Submission of Further Information

**Proposed Temporary Private Vehicle Park (Private Cars) for a Period of 3 Years in
“Village Type Development” Zone, Lot Nos. 543 (Part), 544 (Part), 546 (Part),
547 (Part), 548 (Part), 549, 550 (Part), 551 (Part), 552 RP (Part), 553, 603 S.A RP,
605 (Part), 606 RP, 607 (Part), 608 (Part), 609 RP and 610 RP (Part) in D.D. 218
and Adjoining Government Land, Ma Kwu Lam Village, Sai Kung North, New Territories**

Further Information (4) for Planning Application Nos. A/NE-SSH/156**Response-to-Comment****Comments from Drainage Services Department received on 31.5.2024**

Plan 6.1a
(P 23055A)

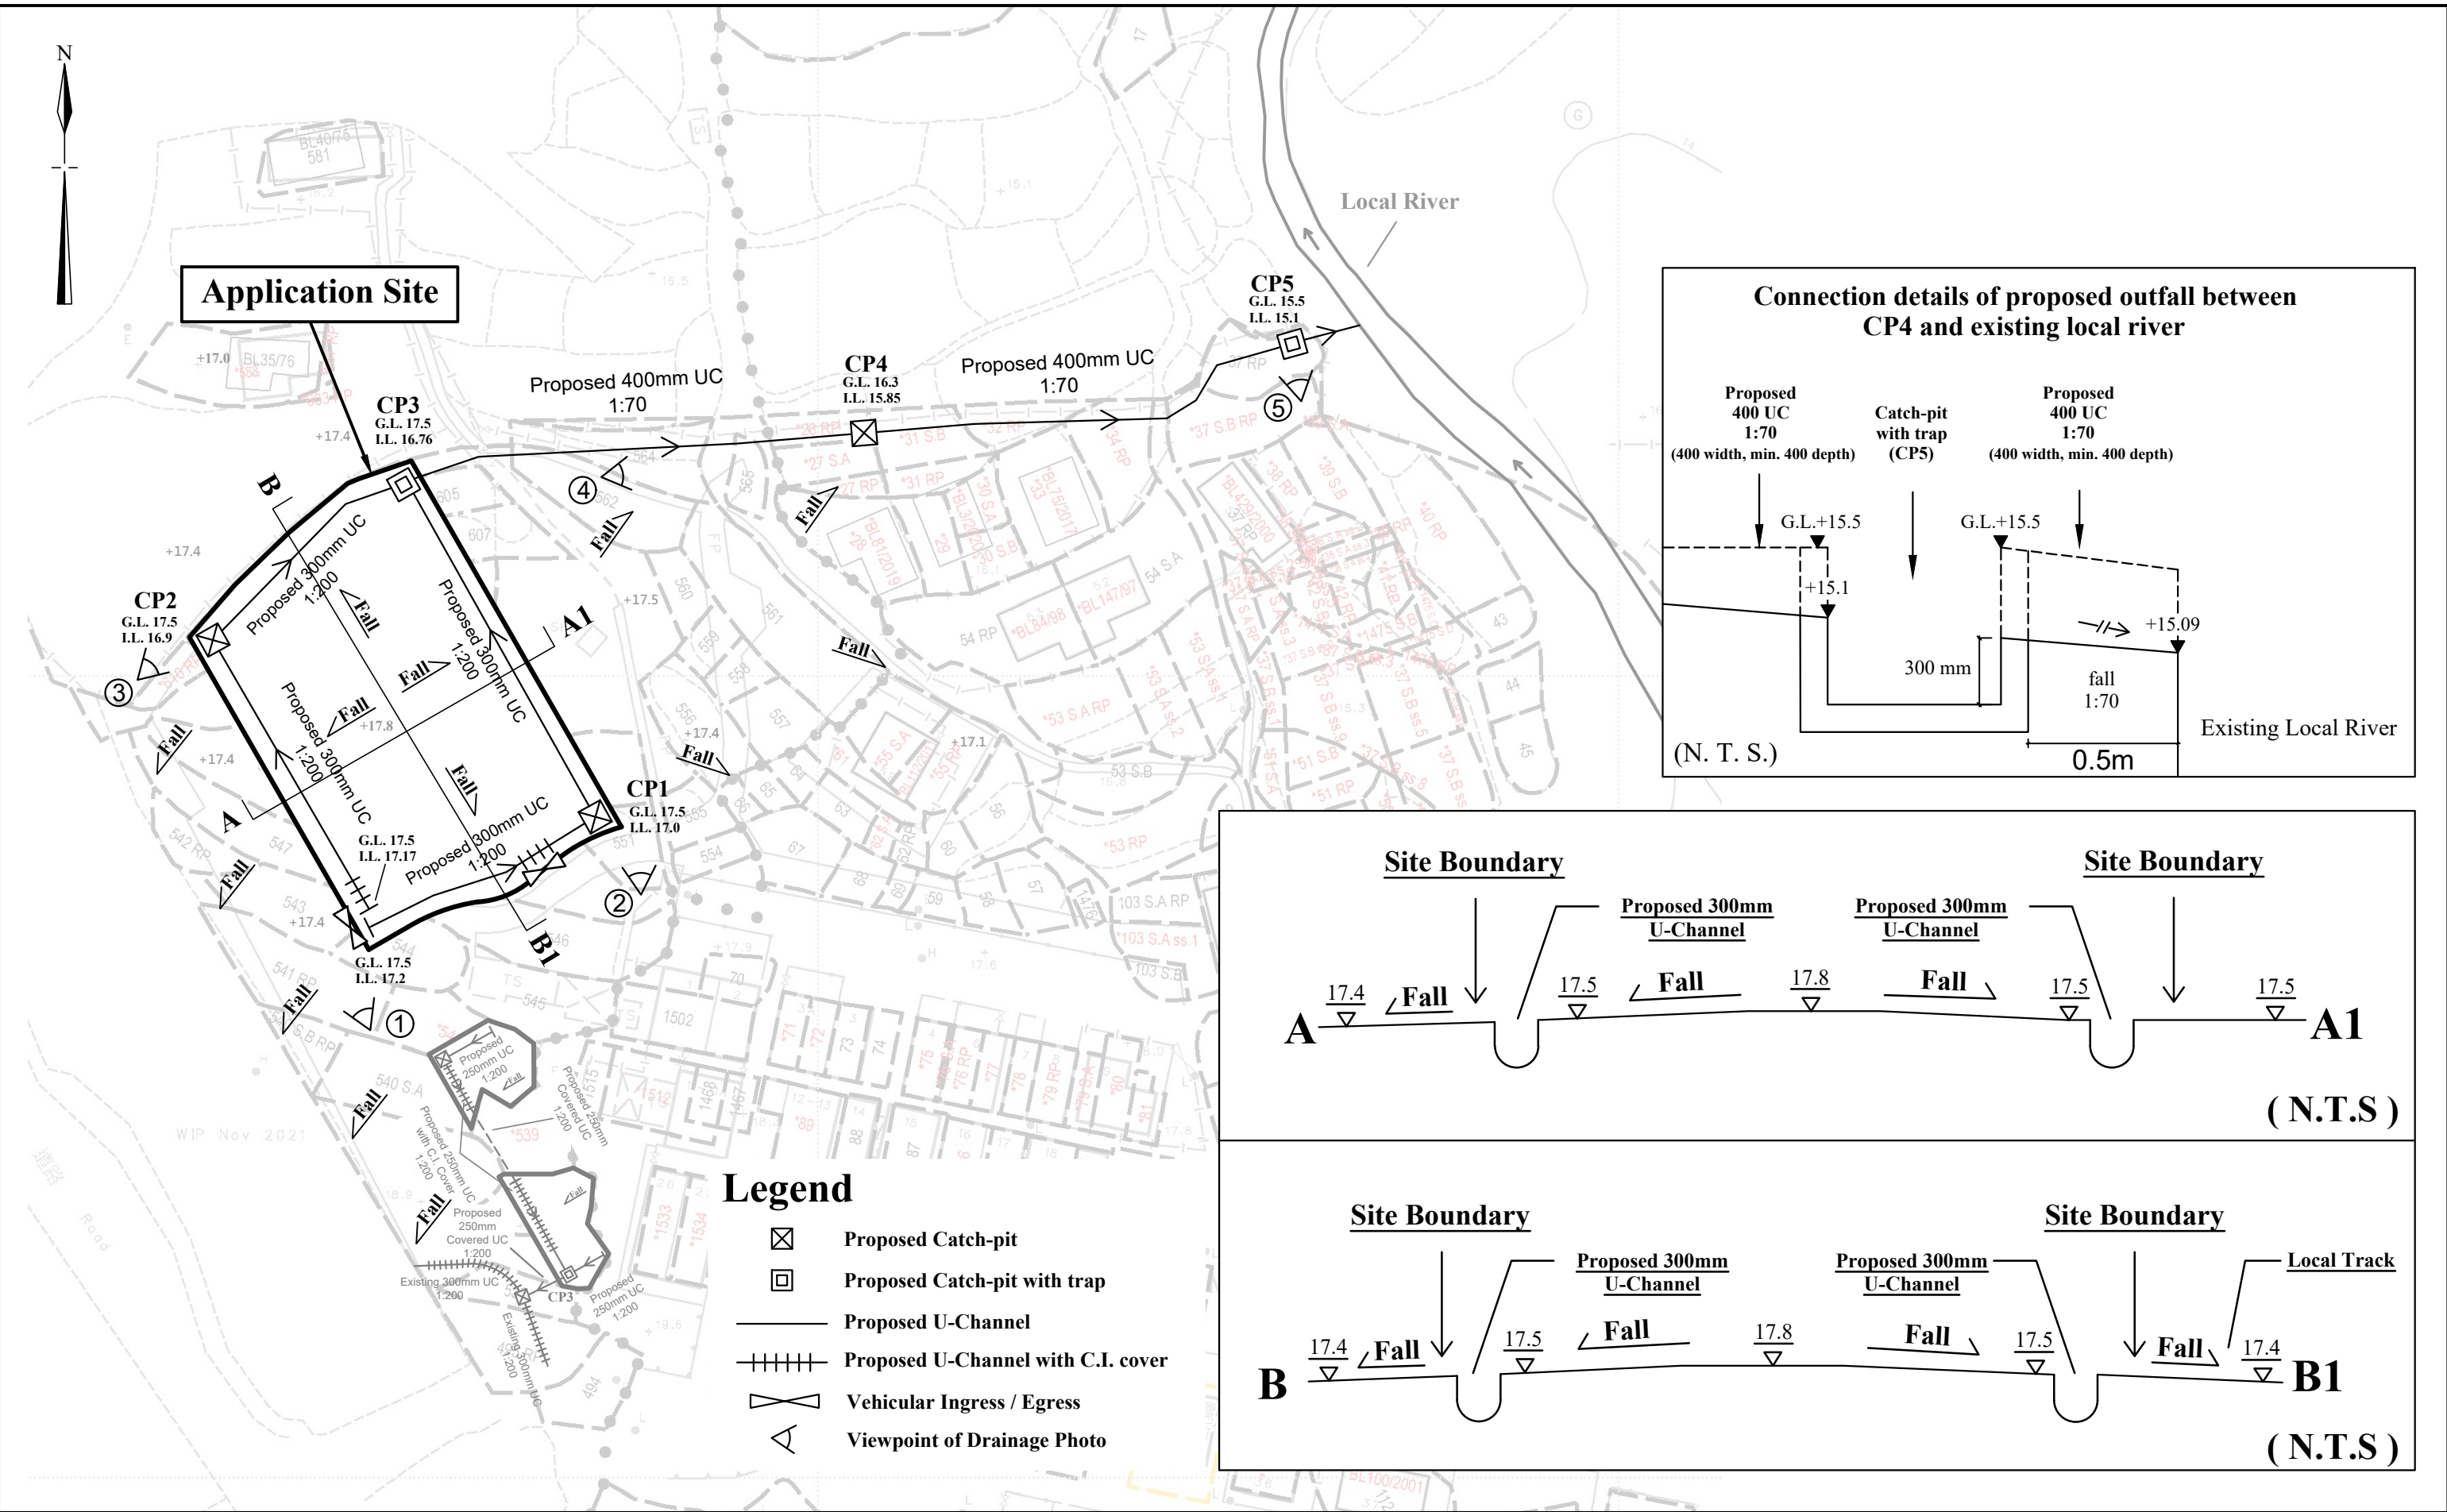
(b)	Please justify your proposed catchment area. (Please provide support evidence for all directions of the sites)	Catchment area is updated. Ground levels of surrounding area are indicated on Plan 7.2.

Catchment Area A
Concrete Paving : 850m²

Catchment Area C
Concrete Paving : 118m²
Flat grass land : 2,043m²
Total Area: 2,161m²

Catchment Area B
Concrete Paving : 929m²

Plan 6.3
(P 23055A)

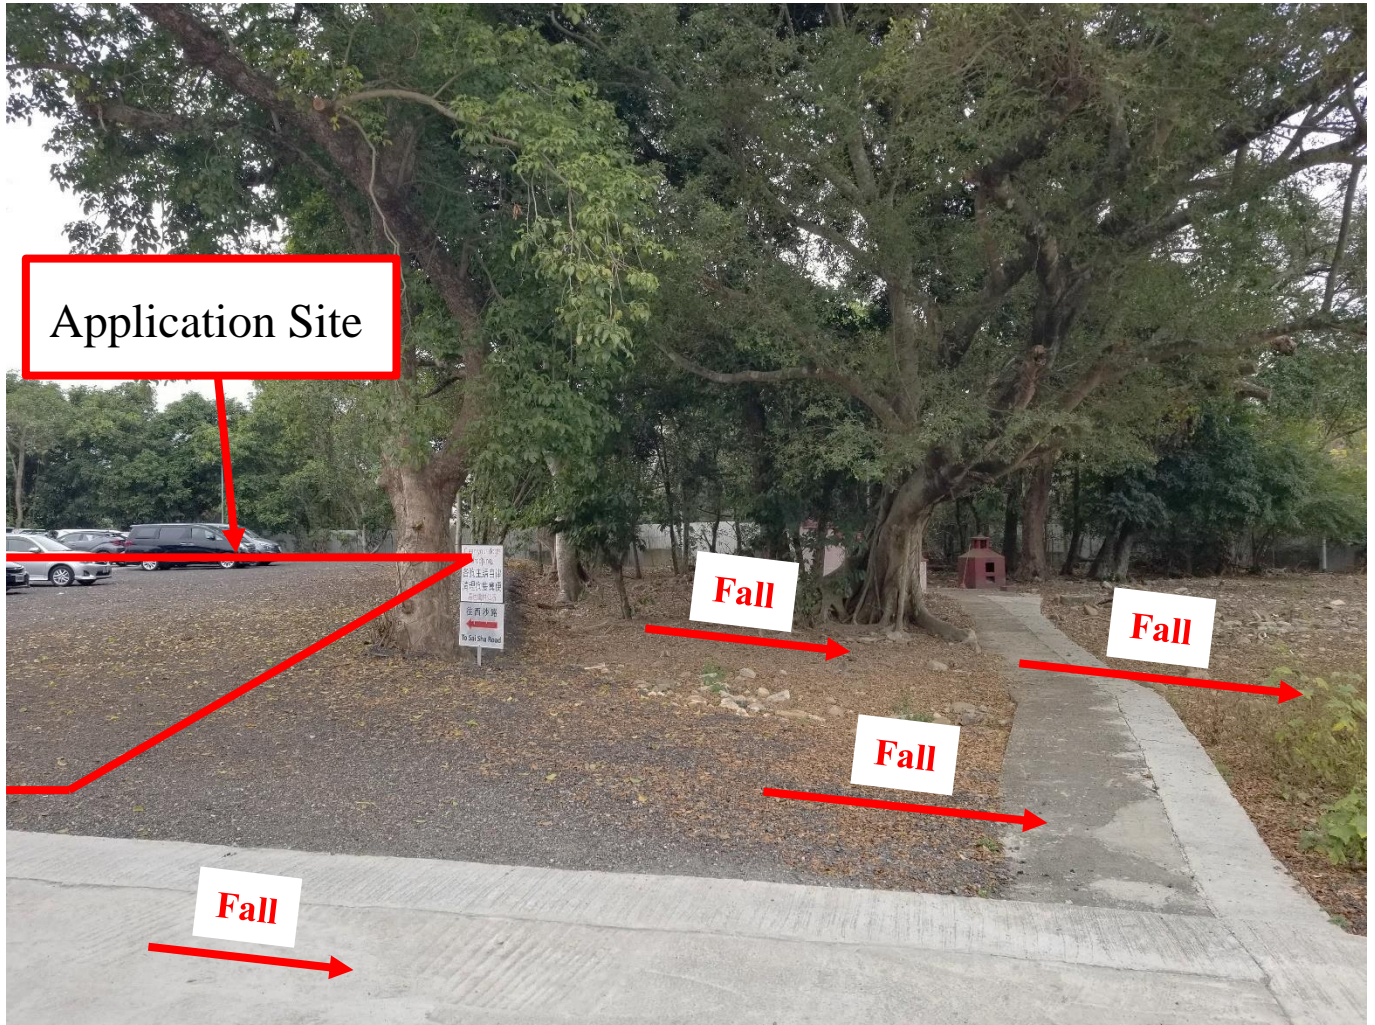
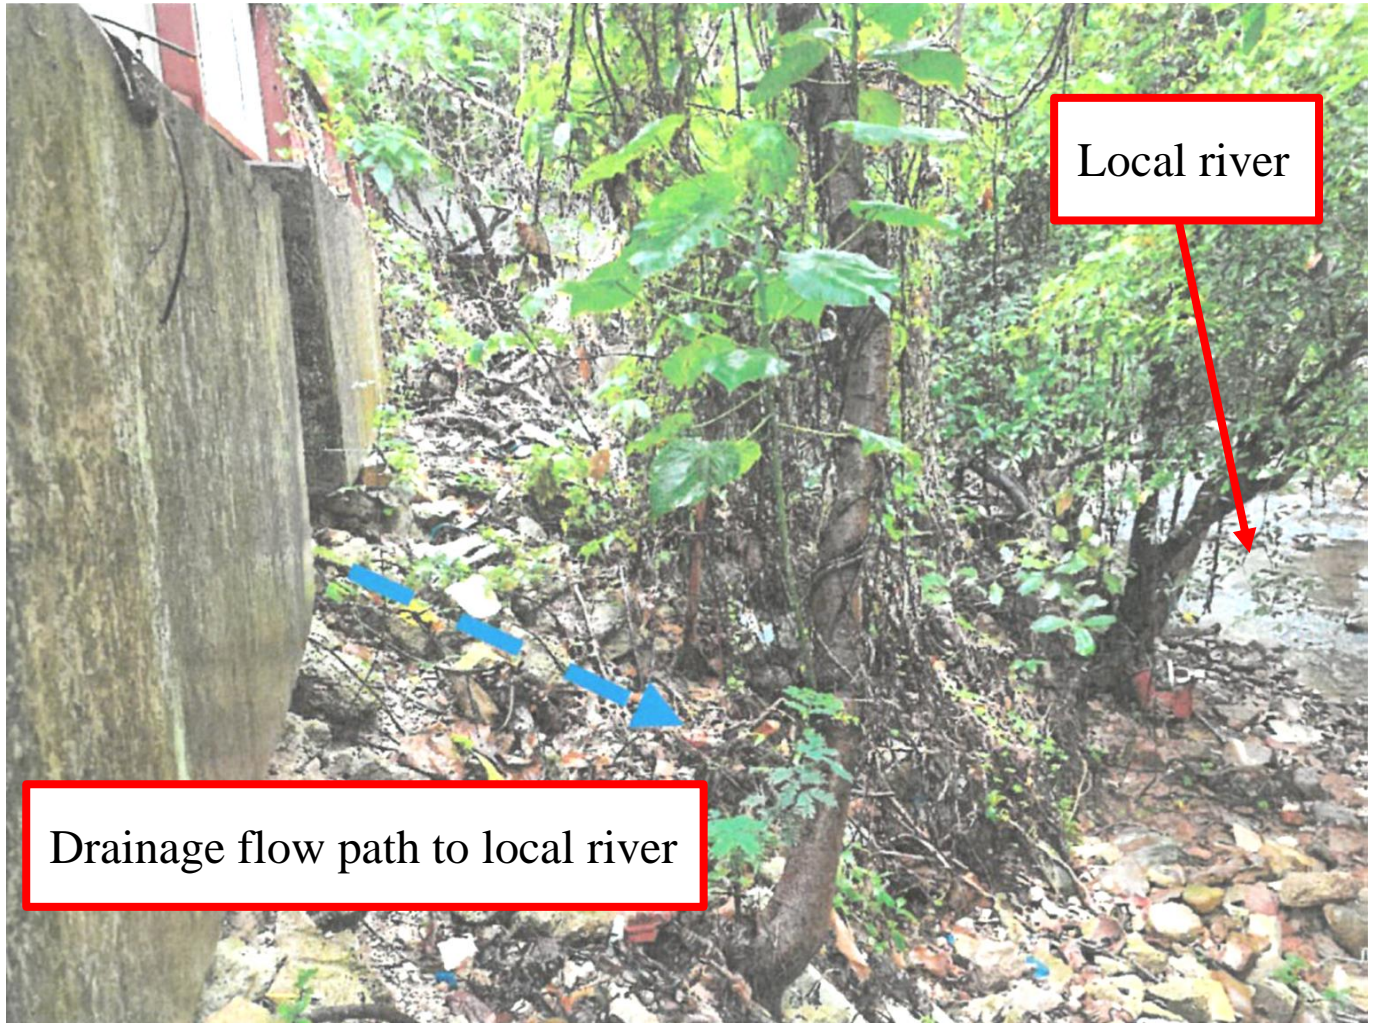
(c)	The drainage flow path from the development to the public drainage system / streamcourse / sea / any recognized drainage facilities should be provided in association with supporting site photos for the captioned submission. (photos for the locations of proposed 450UC and outfall for SSH_156).	Please refer to the attached site photos showing the drainage flow path and the local river.
